I am a resident of 1515 15th Street, NW (The Metropole) and I will be directly impacted by the proposed development at 1456-1460 Church Street, NW, as my residence looks directly across the alley to the building site. I am submitting this letter because I will be unable to attend the hearing for this case scheduled for October 22, 2012, as I will be out of town for medical purposes. This letter will present my concerns and will attempt to highlight some of the reasons why the variances and special exceptions requested by the developer should not be granted.

Case # 18638
Mesterhazy letter in opposition

BOARD OF ZONING ADJUSTMENT
District of Columbia
CASE NO. 18638
EXHIBIT NO. 30

Picture 1. Elevation from Applicant's Elevation Plans showing Seventy-Five (75) Feet Height of Building as well as implication that it is the same height as the existing adjacent condominium on Church Street

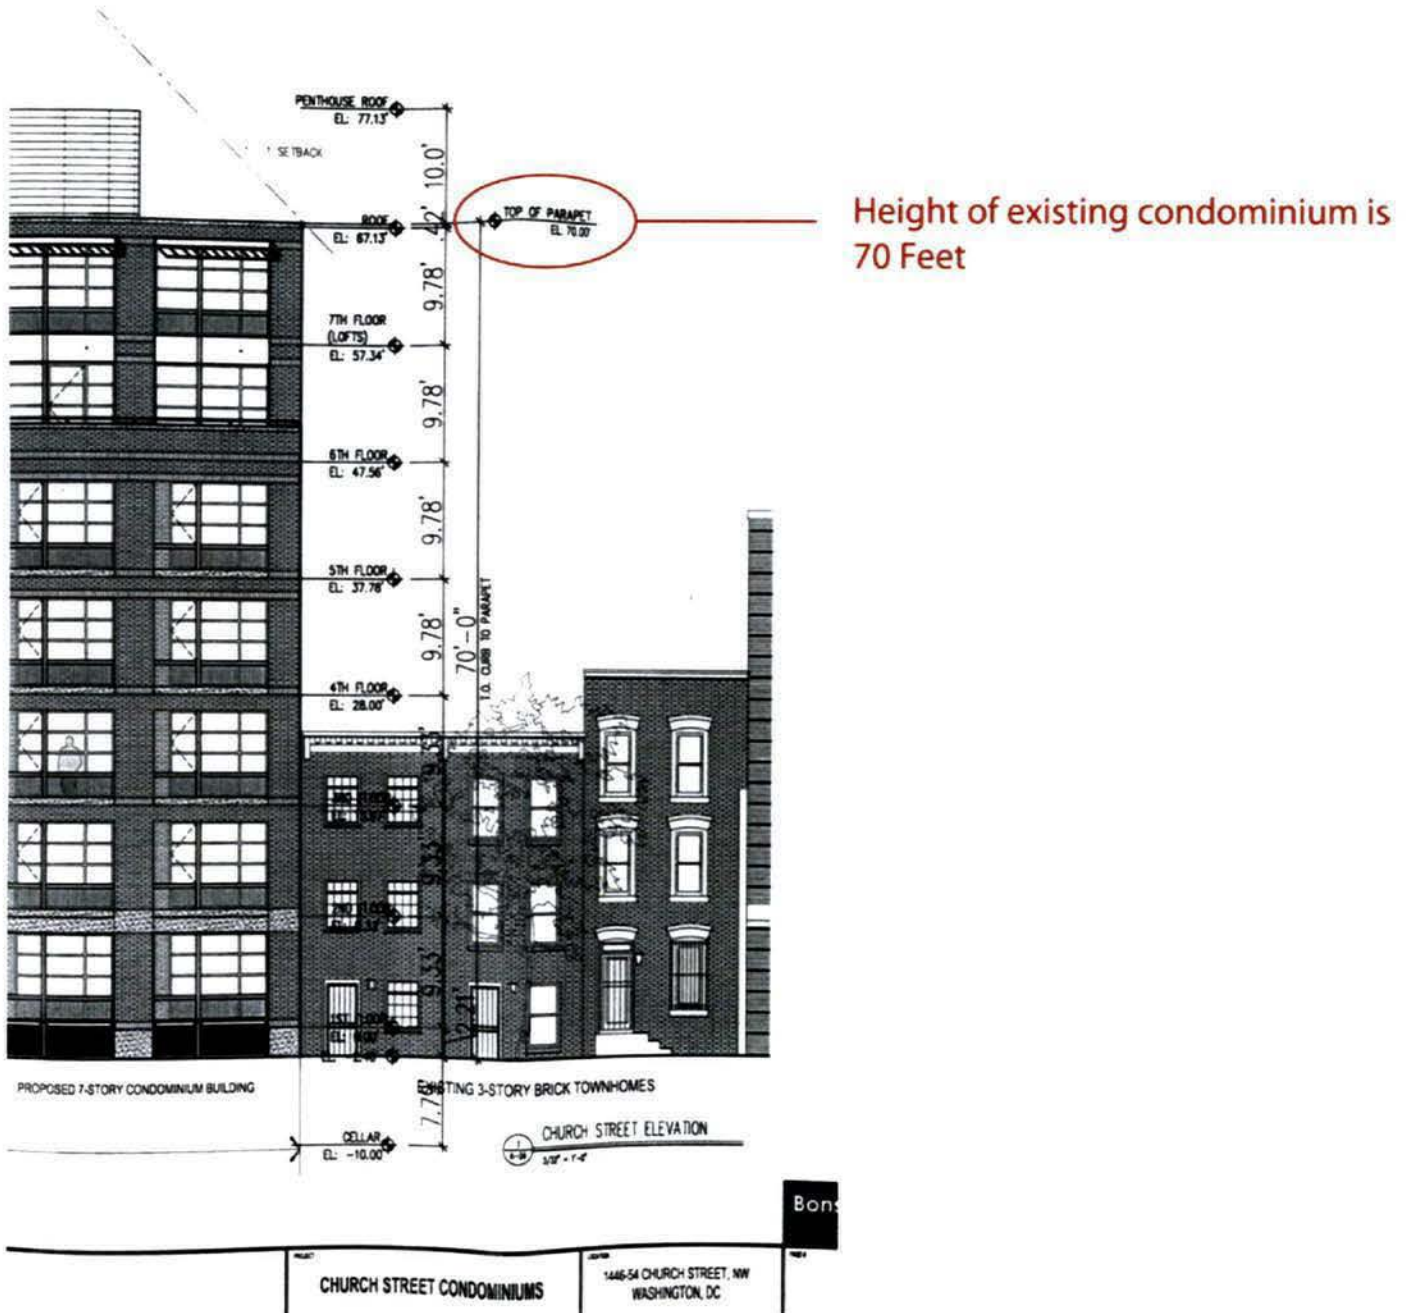
Likewise, the graphics that show the measured height of the building at 75' also show the building to be the exact same height as (from the top of the parapet) the building immediately east on Church Street. **(See Picture 1)** However, according to documents in BZA case 17459 for 1446-1454 Church Street, this building is only 70' in height. **(See Picture 2)** Either the height in the current proposal is inaccurately represented in the drawings, or the height of the existing building at 1446-1454 Church Street is not in conformance with the plans submitted to the BZA back in 2006 (and exceeds the allowable height of 70' within the Height Act – see next section on height concerns). Given that other pages of the submission have proposed floor heights that equal to 75', I am making the assumption that the applicant is proposing a building height of 75' instead of 70'. **(See Picture 3)**

Picture 2. Elevation of existing condominium on Church Street adjacent to proposed building showing a height of seventy (70) feet. (Graphic from BZA case 17459)

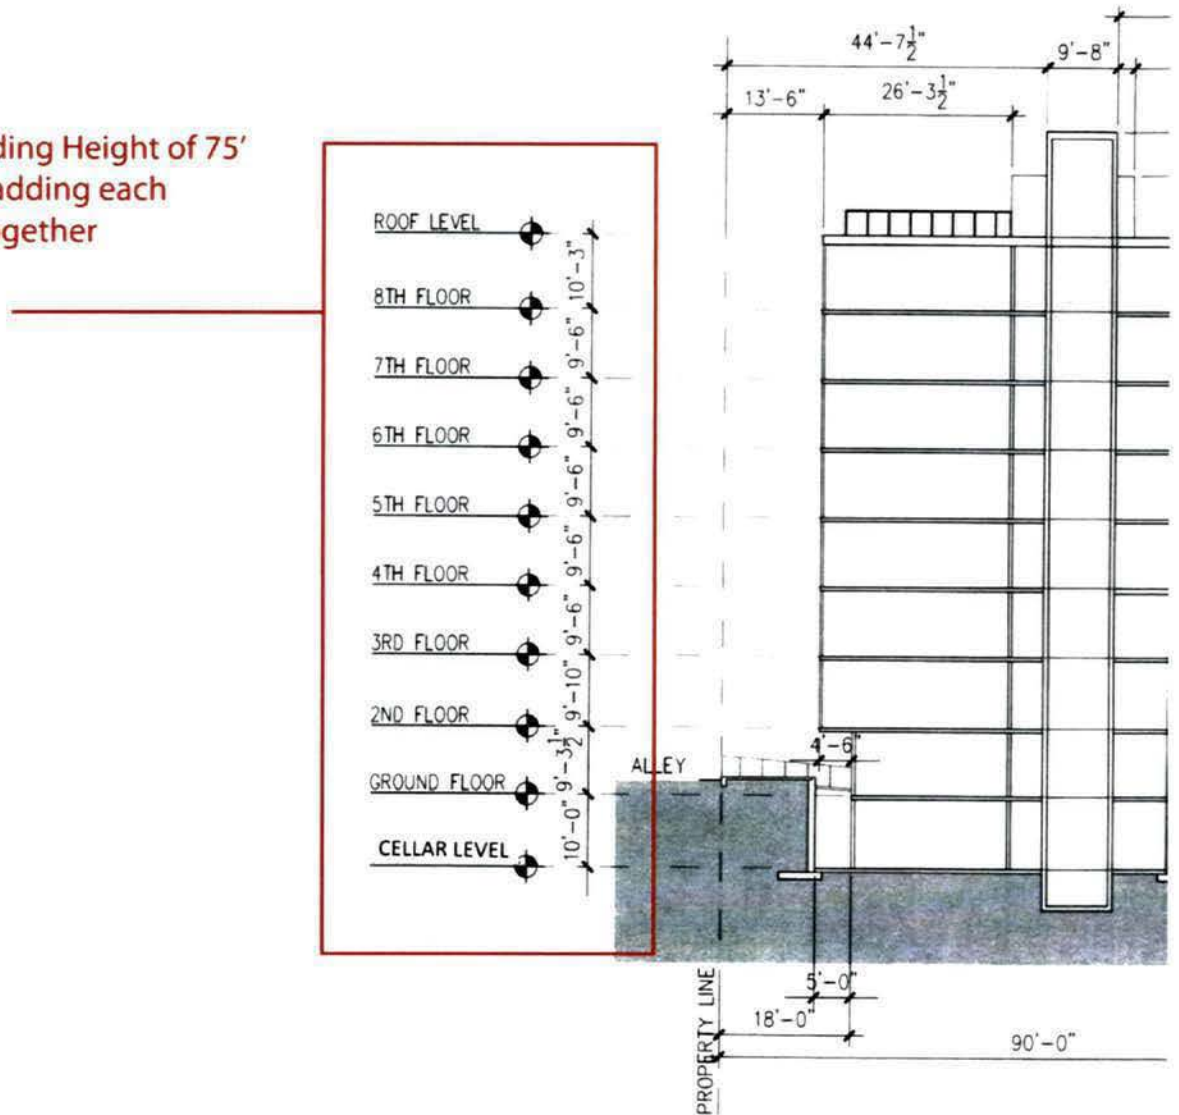
Proposed Building Height of 75' confirmed by adding each story height together

Picture 7. Proposed Development parking space size challenges

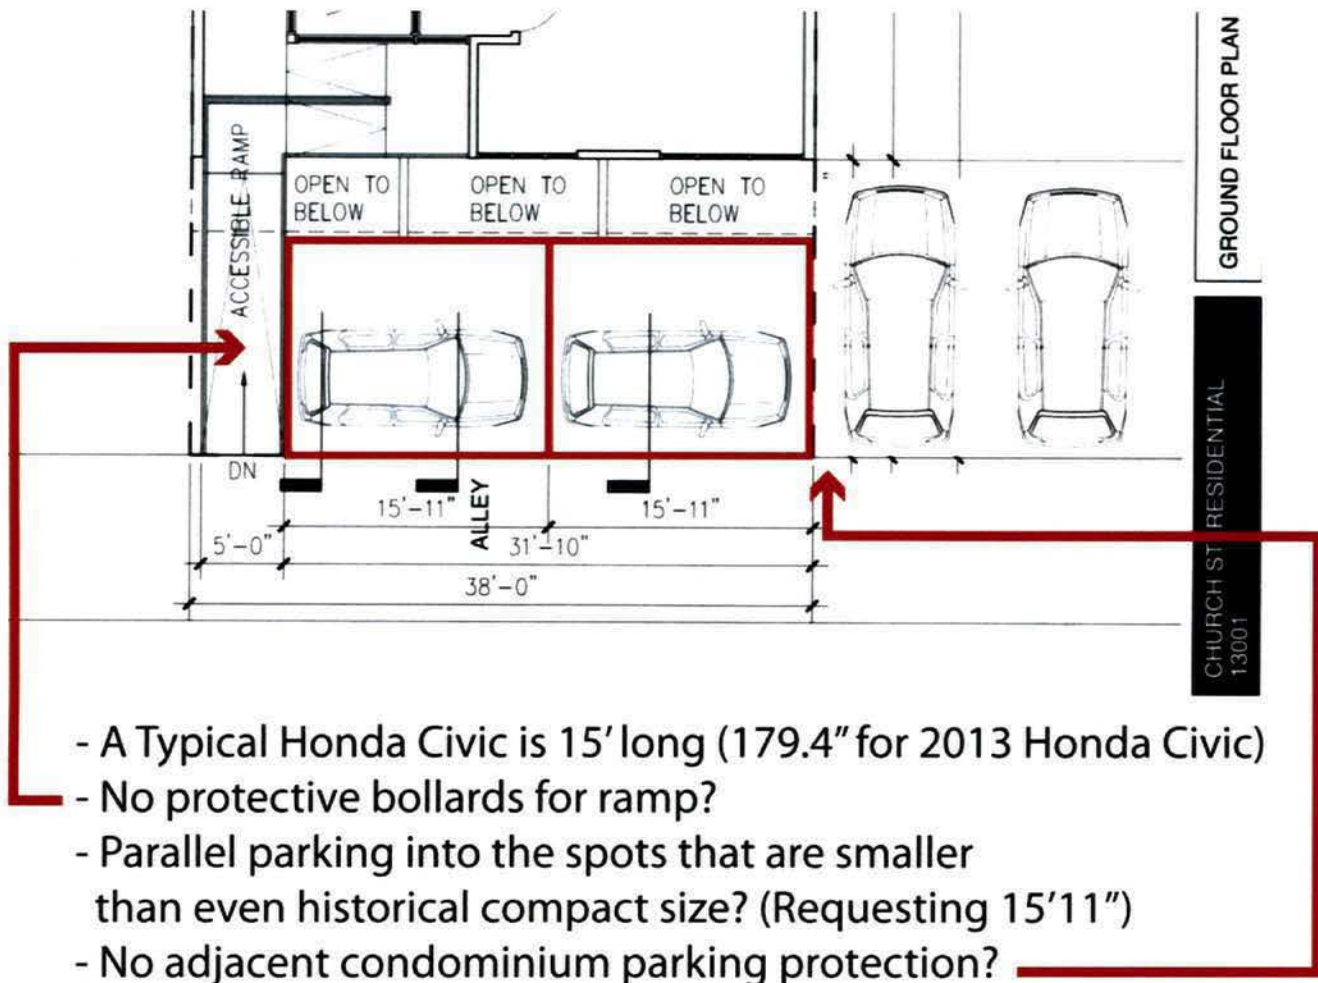
Apart from the variance relief requested from the required number of parking spaces, the applicant's October 8 2013 statement, on page 12, also notes that the two parking spaces that are proposed will be sub-standard in their length; that is, they will be only 15 feet, 11 inches in length—less than the 19 feet required under 2115.1. It does not appear that the applicant has requested required relief for the size of these spaces. The applicant does note that the proposed spaces will be 1 inch less than the 16-foot long spaces allowed for historic resources, and cites section 2115.3. However, section 2115.3 only notes the size required for compact spaces.

As a result of this I also believe that the **applicant would actually need to request an additional variance for the size of the proposed two parking spaces**, even if the parking variance under section 2101.1 were to be approved, as the parking spaces that they are proposing do not meet the required size per zoning code.

Furthermore, I question whether the two parking spots would actually even work for this space, given their small size and the requirement for parallel parking, as well as no indication of any protective equipment to prevent damage to the proposed ramp or adjacent condominium parking. **(see Picture 7)** When such protective structures are included, they would reduce the size of the parking spaces even further. This would seem reduce the parking spots from two to one to accommodate such a limitation in space.

In addition, if these parking spots were built, I am not sure how they would accommodate most modern cars and still be usable. For instance, a Honda Civic (a small to mid-sized car) is 179.4" in length, or nearly 15 feet long. A Toyota Prius is 175.3" in length, or just over 14 and one-half feet long. How would these cars actually be able to park in these spots, without hitting each other or the wall separating the ramp?

Picture 8. Transportation Plan by The Metropole, which shows existing easement and privately owned space that would be potentially blocked.

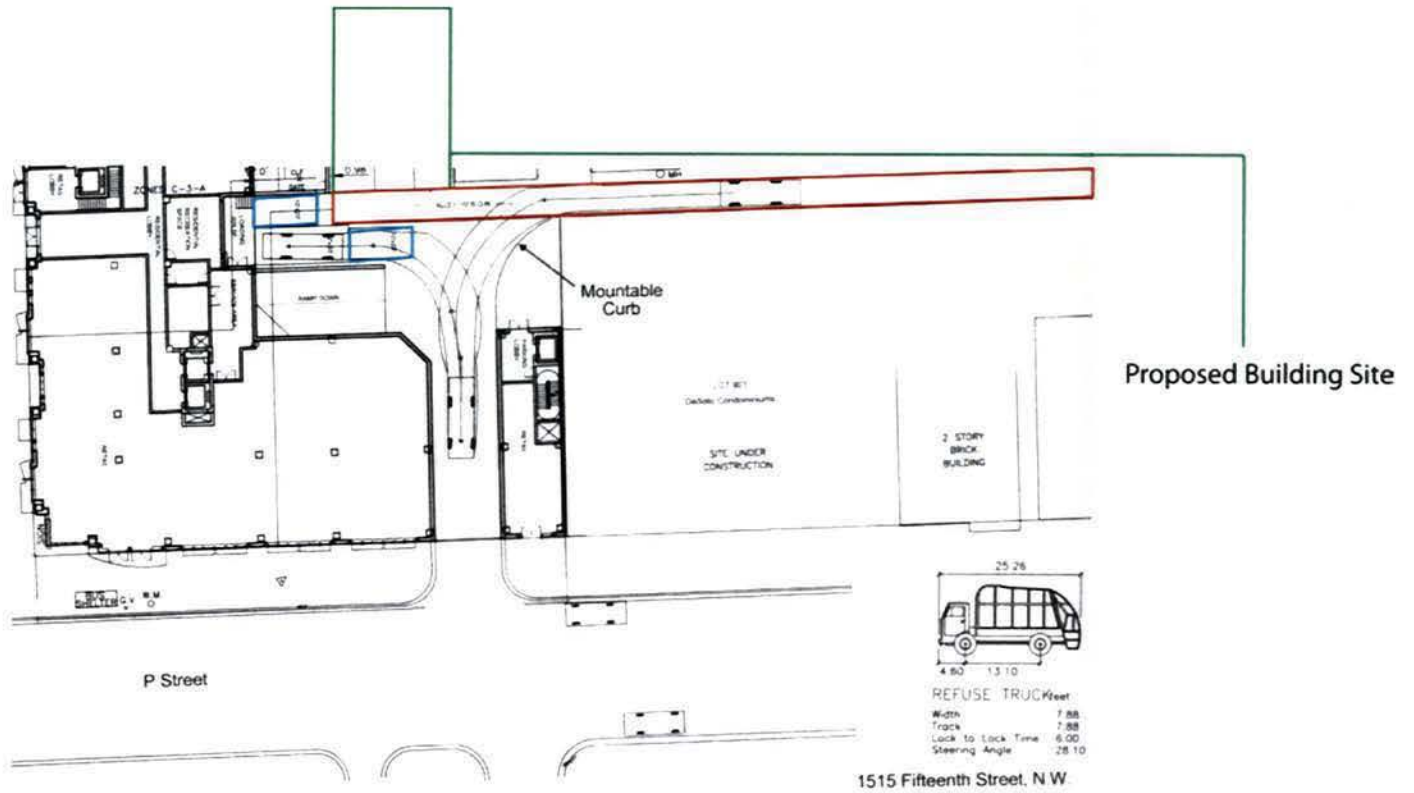
The proposed two parking spaces for the building would mean that any use of the alley for trash pickup, deliveries, moving trucks, etc. would result in the blocking of an existing easement or currently owned space by the adjacent structures.

Picture 17.

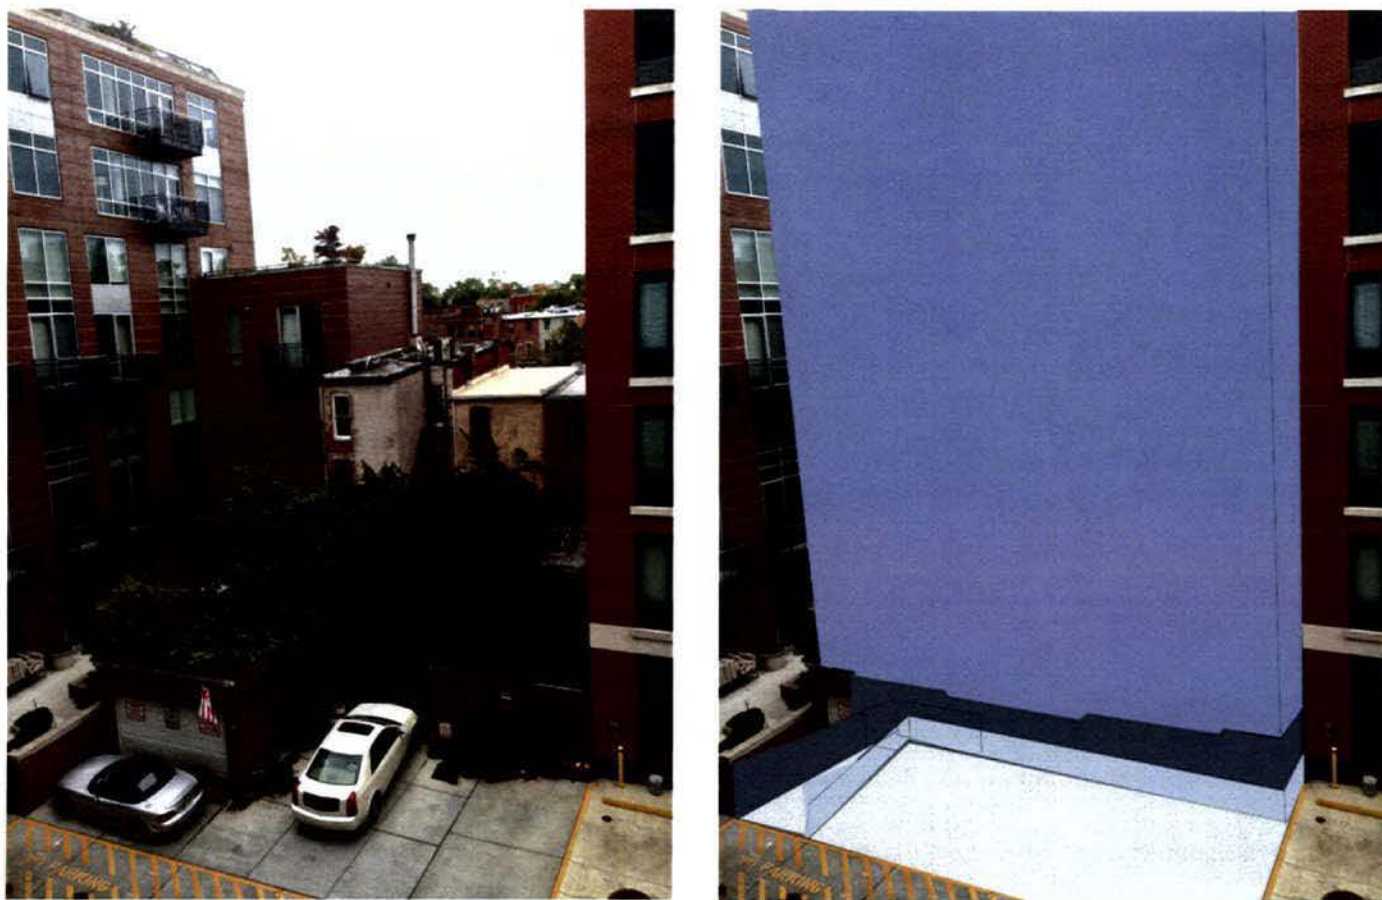
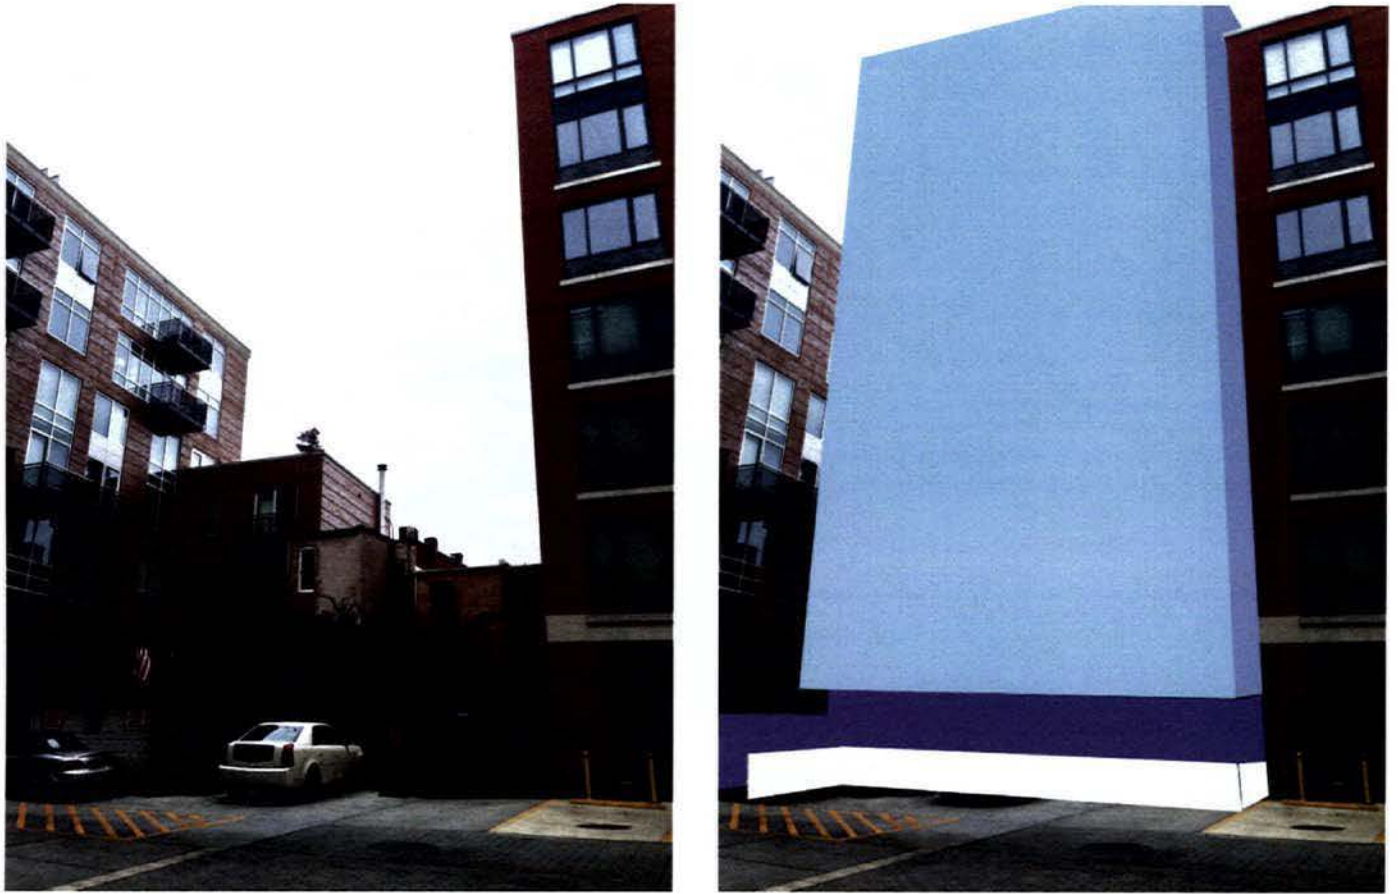
I made the following pictures based off of the applicant's proposed designs and how they would impact the adjacent properties (including my residence).
